17 August 2017

The Hon Paul Green MLC
Planning and Environment Committee
NSW Legislative Council
Parliament House
6 Macquarie Street
Sydney NSW 2000

**NSW Parliamentary Inquiry - 'Energy from Waste' Technology
Supplementary Submission on behalf of Jacfin Pty Ltd**

Figure 1 Comparison of NOx emissions from EfW with highest existing NOx sources in Sydney based on NPI 2014/15

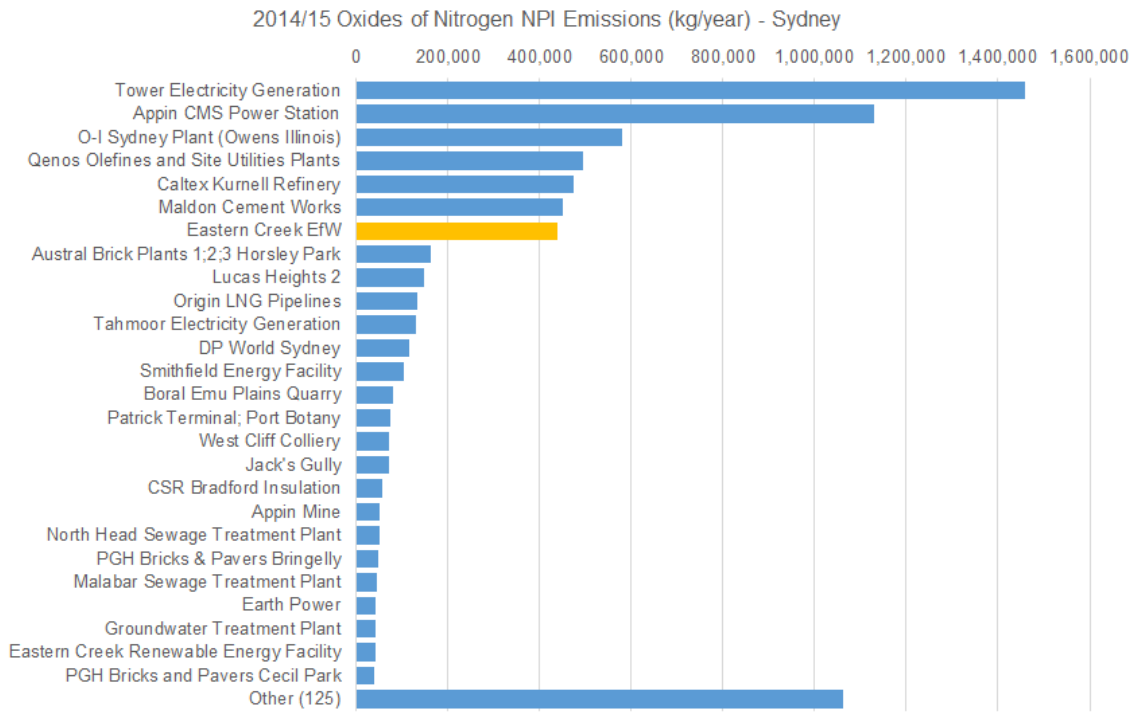
- Figure 1 compares NO_x emissions from EfW with highest existing NO_x sources in Sydney based on NPI 2014/15. Figure 1 shows that, with the adoption of SNCR, the EfW would be the seventh highest emitter of NO_x.

- Even with SNCR, the EfW represents an additional 5% of NO_x emissions into the Sydney airshed based on 2008 Inventory data. Upset emissions would represent a considerably greater emission rate.

- The ozone assessment did not consider higher emission scenarios, such as due to upset conditions. The lack of assessment of upset conditions was explained in Appendix M as due to upset conditions being of short duration. However, given that emissions during upset were estimated to be ten times higher than normal operational emissions and that upset conditions could occur for up to 4 hours and for a total of 60 hours per year, the impact of upset conditions is likely to have been significantly underestimated.

Figure 3-15 Greater Sydney's freight assets

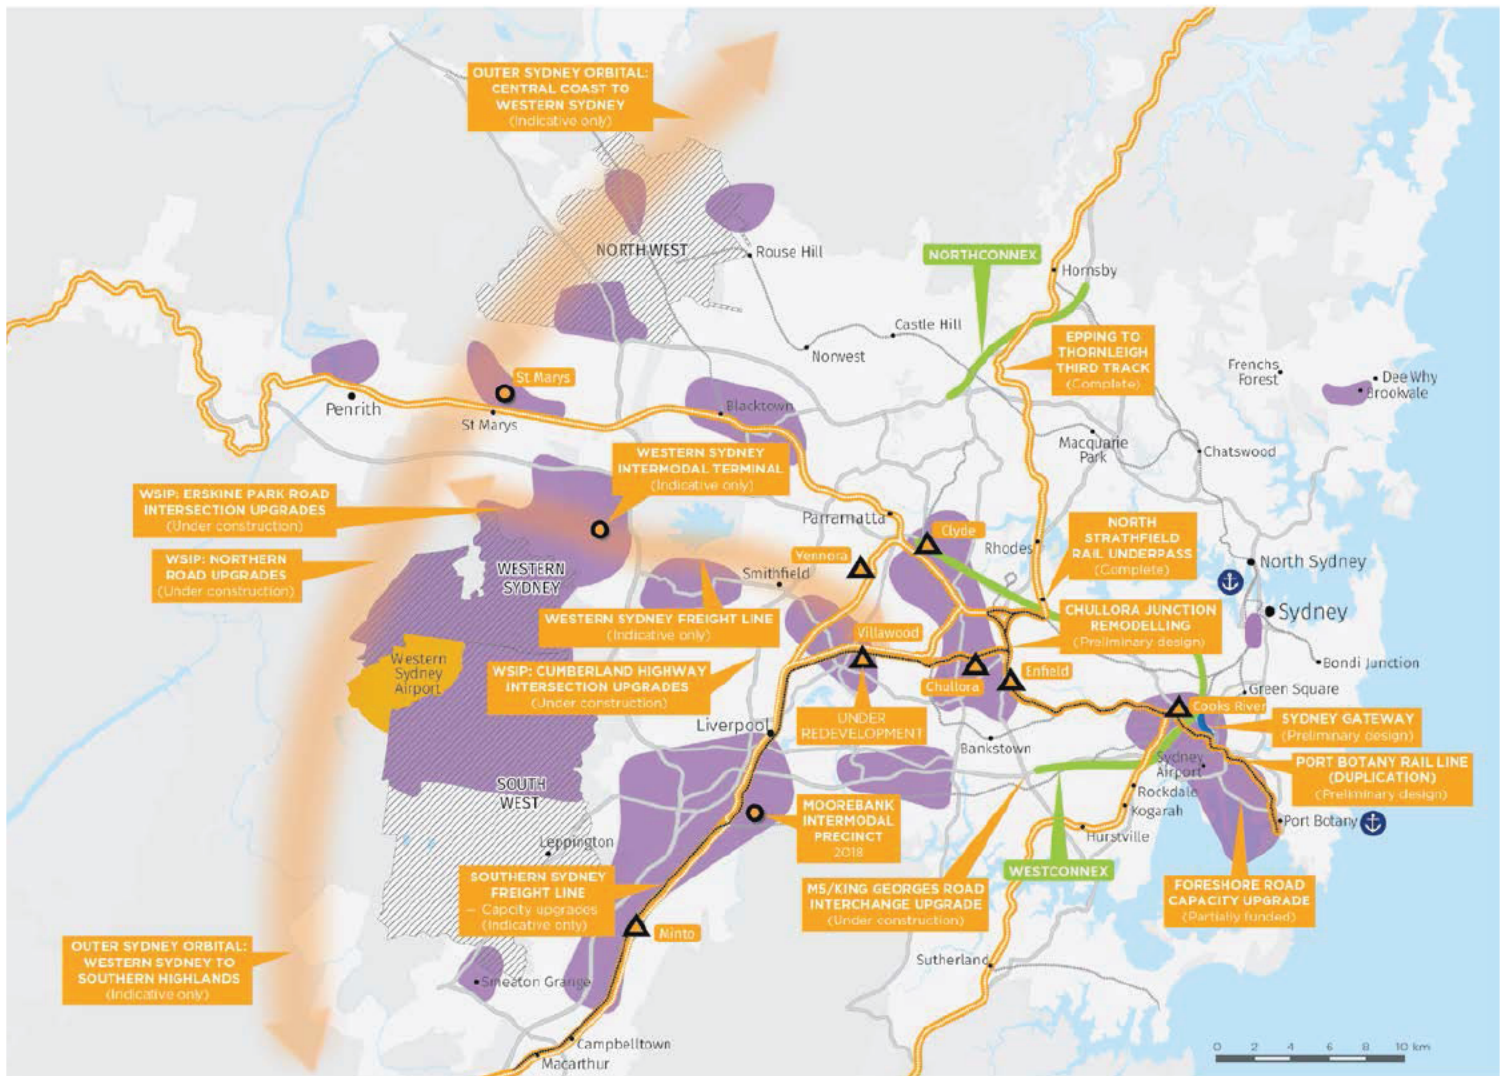
The Draft West Central District Plan and Draft West District Plan make a number of references to the Western Sydney Intermodal Terminal, which is said to be currently under investigation. Figure 3-15 of the Draft West Central District Plan and Figure 3-10 of the Draft West District Plan (see **attached**) show an indicative location for the Intermodal Terminal on or in close proximity to Jacfin's Eastern Creek Land.

- (b) The Draft West Central District Plan and Draft West District Plan should not show an indicative location for the Western Sydney Intermodal Terminal until a proper planning assessment of the appropriate location of that facility has been undertaken. It would be premature for the NSW Government to develop or dispose of the DPE Land until the location for the intermodal facility has been finalised. Jacfin contends that the appropriate location for the intermodal terminal is the DPE Land.

Figure 3-15 Greater Sydney's freight assets

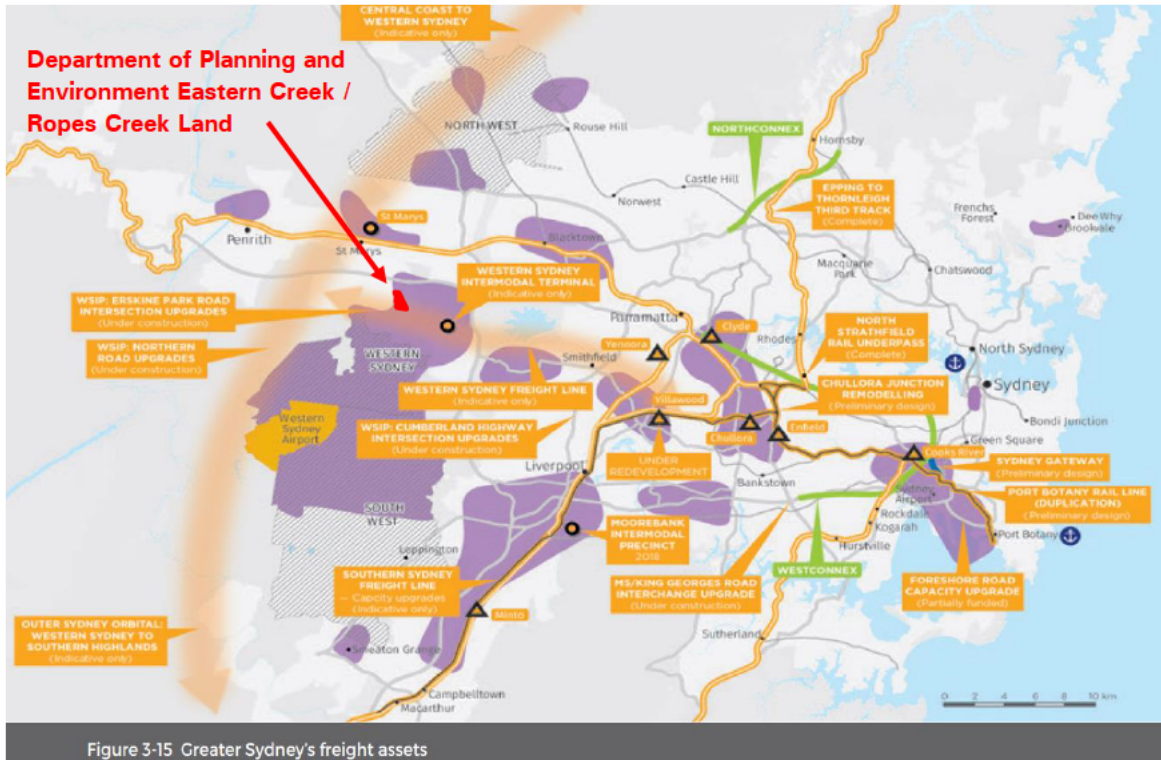
Further, it is highlighted that the NSW Government owns a parcel of currently undeveloped land located adjacent to Ropes Creek which was the subject of a draft Development Control Plan exhibited in November/December 2016. The indicative location of this land is shown in **Figure 2** below, against the background of the Greater Sydney’s freight assets map. This is the most suitable site for the location of the Eastern Creek Intermodal Terminal, and should be the basis for further studies and investigations. On this basis, the Department should not sell or develop its own lands at Eastern Creek / Ropes Creek, until the intermodal terminal investigations have been completed and a preferred site identified.

The Greater Sydney’s freight assets map (Figure 3-15 of the Draft West Central District Plan and Figure 3-10 of the Draft West District Plan) should be amended to remove the location of the Western Sydney Intermodal Terminal at Eastern Creek until further strategic studies and investigations have been carried out to confirm the viability of the freight line and to identify a preferred location for the Western Sydney Intermodal Terminal.

Figure 1 Predicted ground level concentrations – detail from PEL (2016).

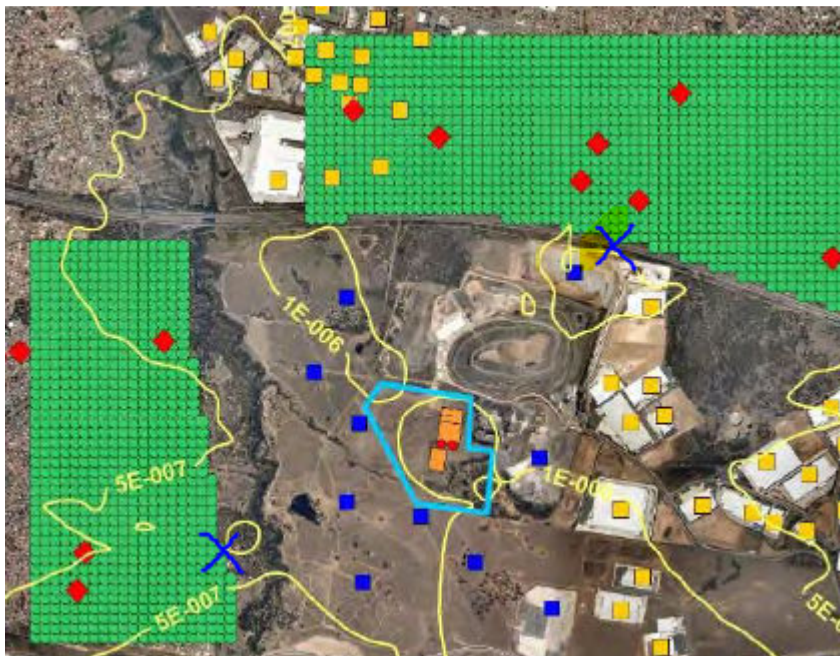
modelling procedure used and the input parameters used. However, as discussed above, questions remain on the reliability of the input assumptions.

PEL (2016) claims, without details, that the height of the stack was chosen based on a sensitivity of decreasing the ground level concentrations. Maximum downwind impacts are most often experienced, for the short-term averaging periods of 1-hour and 10-minutes, at ten times the stack height (i.e. 1 km). This appears to be the result reflected in the contour plots within the report (see blue 'X marks the spot' in Figure 1). This includes the residential receives identified on a grid to the west of the proposed facility (and a little further beyond to the north-east).

Figure 1

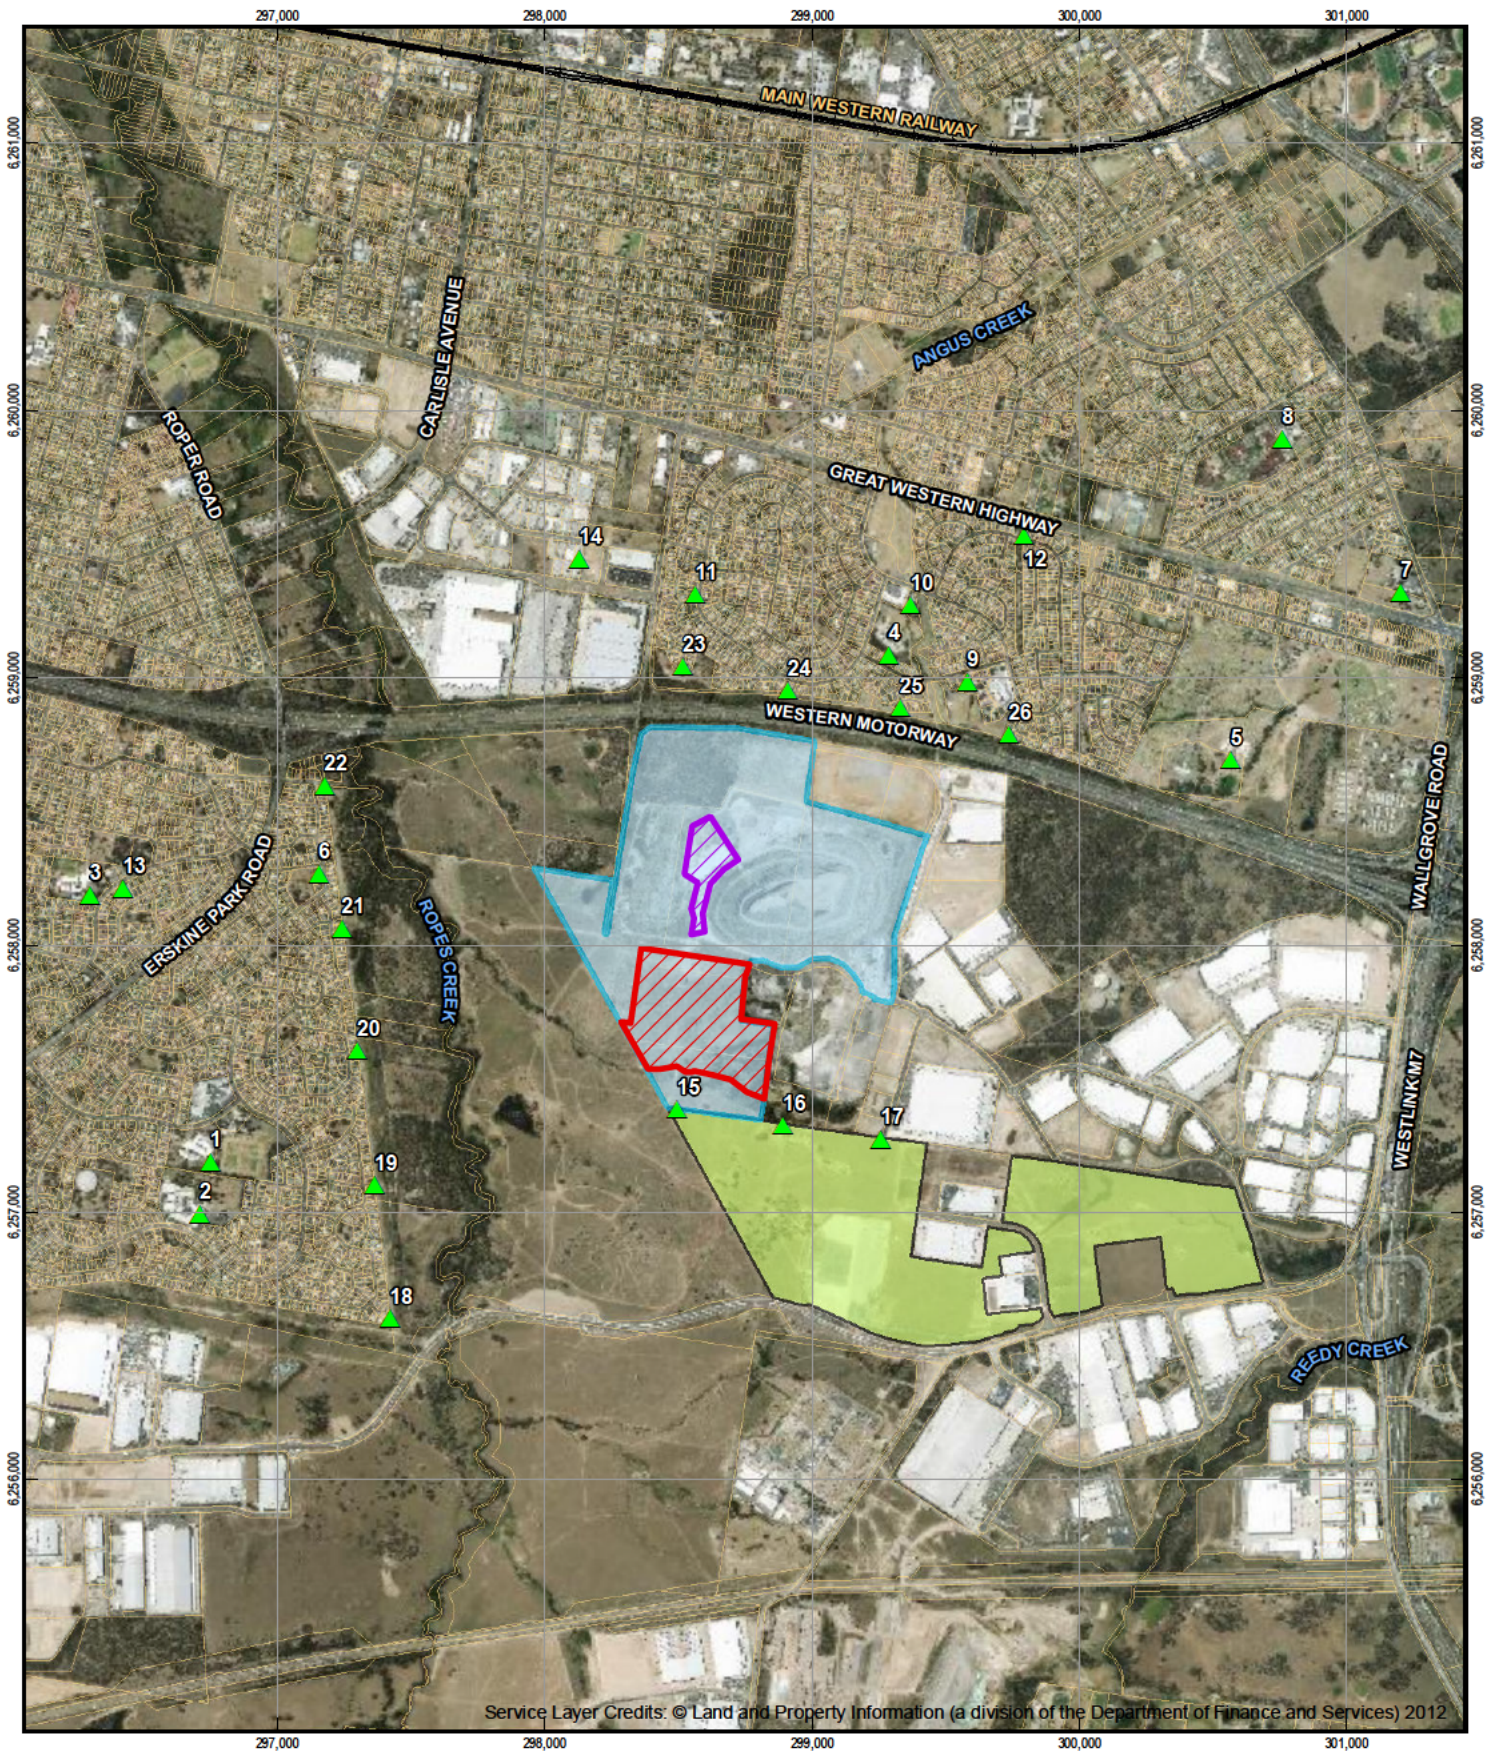
A map showing the location of the Next Gen Facility, Genesis Facility and sensitive receptors is shown in Figure 1. Additional receptors have been included in the model as the nearest receptors to the site which were not included in the EIS Odour Assessment.

Results of the modelling for the five assessed scenarios are presented in Table 3. Shaded results indicate a predicted exceedance of the NSW EPA odour criteria. Odour contour plots of each scenario are presented in Figure 2 to Figure 6, in Attachment A.
